# PLANNING PROPOSAL AMENDMENT REPORT

2-32 JUNCTION STREET FOREST LODGE S11792

**JULY 2016**

### COS - COMMENTS

**PROPOSED MASSING FEBRUARY 2016**

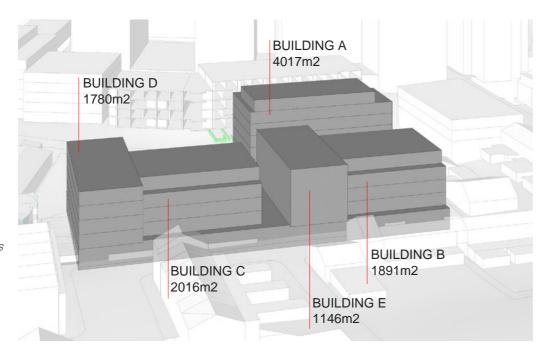
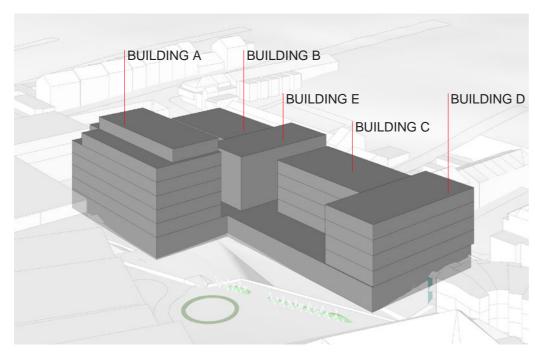
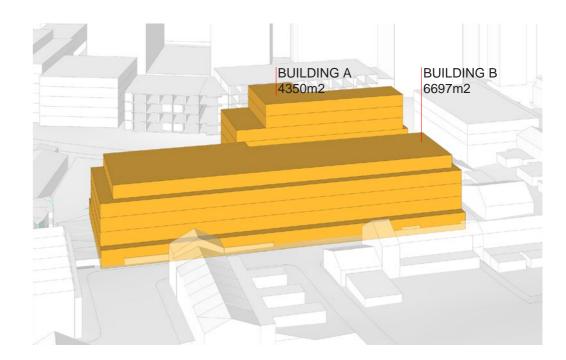
### **OVERSHADOWING**

The proposal need to comply with Parts 3B and 4A of the Apartment Design Guide. In particular, the proposal needs to ensure at least 70% of apartments in neighbouring buildings receiving 2 hours or more of sunlight. Additionally, the apartments that receive less than 2 hours cannot have their sunlight reduced to less than 15 minutes measured on the horizontal plane 1 metres above the floor level. Under the current scheme, the number of apartments receiving 2 hours or more is reduced to 70% and the number of apartments receiving no sunlight (measured on the horizontal plane) is increased by 3 apartments from 27.5% of apartment to approximately 30% of apartments. The proposal needs to be amended so the 3 apartments receive at least 15 minutes of sunlight measured on the horizontal plane.

Information also needs to be provided about overshadowing impacts on the apartments at 2A Short Street. Impacts also need to comply with the Apartment Design Guide.

### SIDE SETBACKS

The proposal needs to comply with Part 3F of the ADG. In particular, typical floor plans need to be provided showing the side setbacks between habitable and non-habitable rooms. This includes Buildings A, B and D. If typical floor plans are not provided, it will be assumed the rooms with windows facing the side boundaries are habitable. In this case, rooms with windows on levels above 12 metres need to be setback at least 9 metres from the side boundaries. Alternatively, if typical floor plans are provided indicating rooms on levels above 12 metres are non-habitable, the rooms need to be setback at least 4.5 metres. Where the basement car park protrudes more than 3 metres above ground level, it will be considered as a storey.

### THROUGH SITE LINK

Relocating the proposed through site link from the central portion of the site to its northern boundary may be considered an acceptable alternative.

### **EXISTING WAREHOUSE**

As the building is a period building in the conservation area, retention and adaptation for residential is likely. The retain scenario needs to assume highest and best use permitted in the zone with lowest efficiency, i.e. the envelope is adapted for residential use with floor space calculated at 75% efficiency. For comparison, an alternative retain scenario based on commercial usage and a higher efficiency should also be provided, in addition to the demolish scenario. To summarise, a total of three of scenarios should be provided.
